INVITATION TO BID
RUNWAY LIGHTS AND SIGNS IMPROVEMENT PROJECT
PROJECT NO. B25-PW-ARP-104015-500657
ADDENDUM NO. 3
APRIL 22, 2025

RUNWAY LIGHTS AND SIGNS
IMPROVEMENT PROJECT

LAKE HAVASU CITY MUNICIPAL AIRPORT
LAKE HAVASU CITY, AIRIZONA

B1 CONSTRUCTION SAFETY AND PHASING PLAN

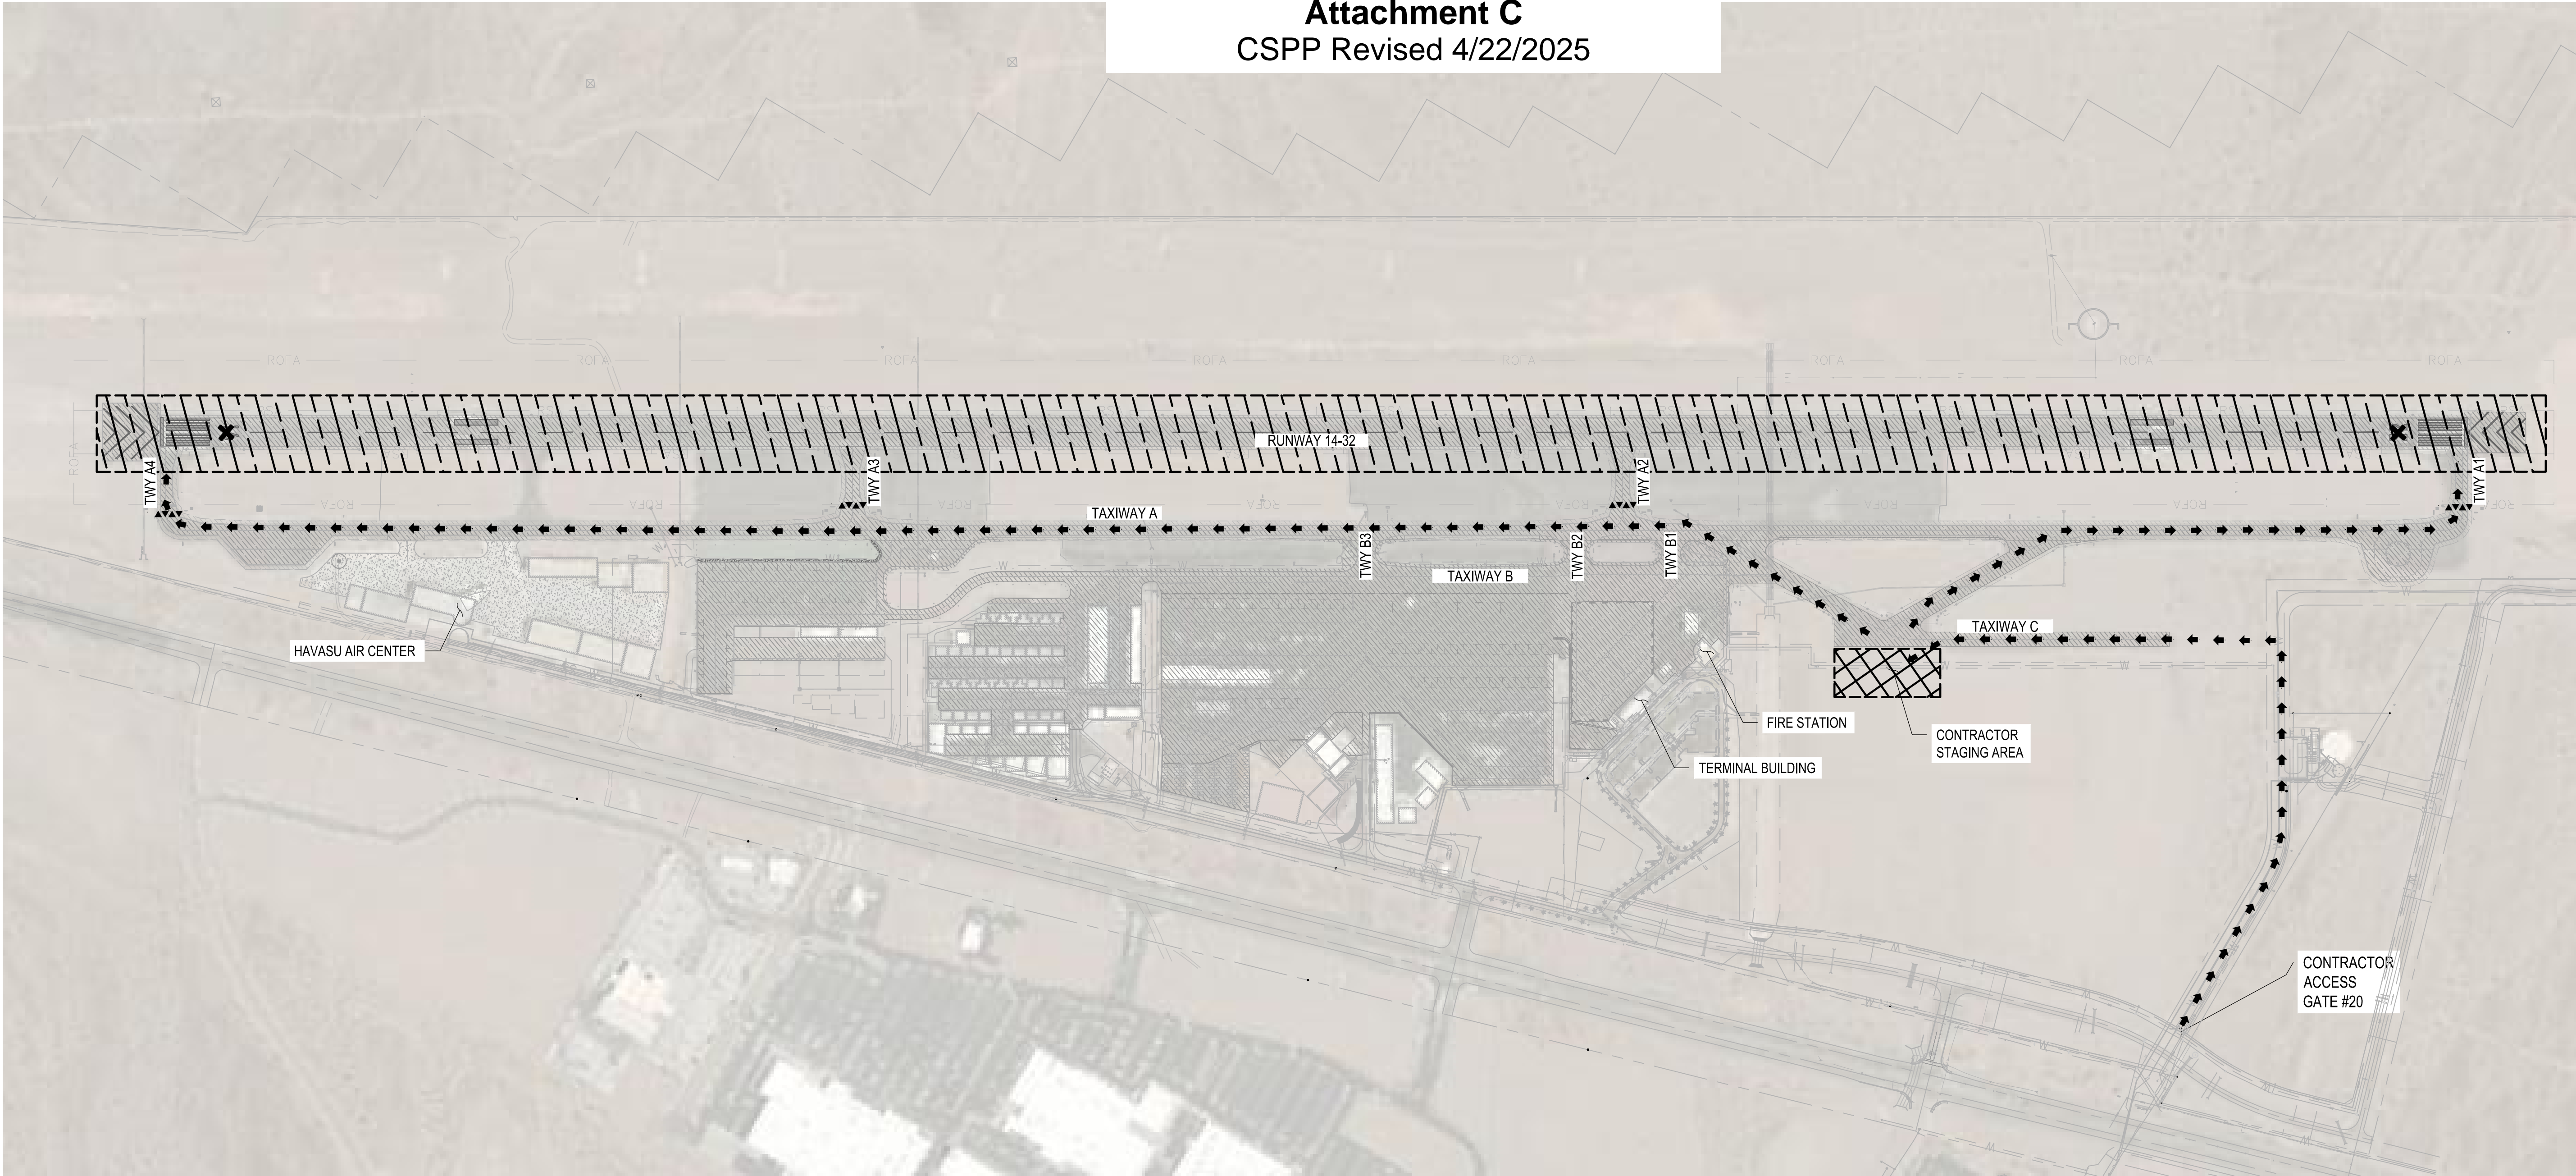
Question 1: "It is my understanding that the FAA does not allow runway edge lights to be partially LED and partially non-LED. In other words, runway night operation can only be resumed when all of the lights have been changed to LED. Therefore, I can't see how work can be completed in segments with the runway being operational at the end of each shift. Please advise."

1. Replace the Construction Safety and Phasing Plan (sheet GC101 (4 of 31)) of the Plans, with the revised Construction Safety and Phasing Plan enclosed as Attachment C.

Answer 1: That is correct. The FAA does not allow runway edge lights to be interspersed. As such, project activities must be planned and staffed in such a way as to restore the runway to operational condition by the end of each shift and permit the opening of the runway for daytime use. Including the final change over from incandescent to LED, which shall be completed during one nighttime closure.

The objective is to complete the work during nighttime closures of the runway while keeping the runway open and lights operational for daytime use, and when nighttime closures are not in effect (e.g. weekends or nights of no work). See also Attachment C, the revised CSPP plan.

1. WORK SHALL BE COMPLETED WITHIN 40 CALENDAR DAYS.
2. ALL WORK WITHIN THE RUNWAY SAFETY AREA SHALL BE PERFORMED DURING NIGHTTIME RUNWAY CLOSURES.
3. NIGHTLY WORK HOURS WILL BE FROM 9 p.m. UNTIL 6 a.m.
4. RUNWAY LIGHTS SHALL BE OPERATIONAL WHENEVER THE RUNWAY IS OPEN TO AIRCRAFT OPERATIONS
5. LED AND INCANDESCENT LIGHTS SHALL NOT BE INTERSPERSED
6. THE SWITCHOVER TO FROM INCANDESCENT TO LED SHALL OCCUR DURING ONE NIGHTTIME RUNWAY CLOSURE
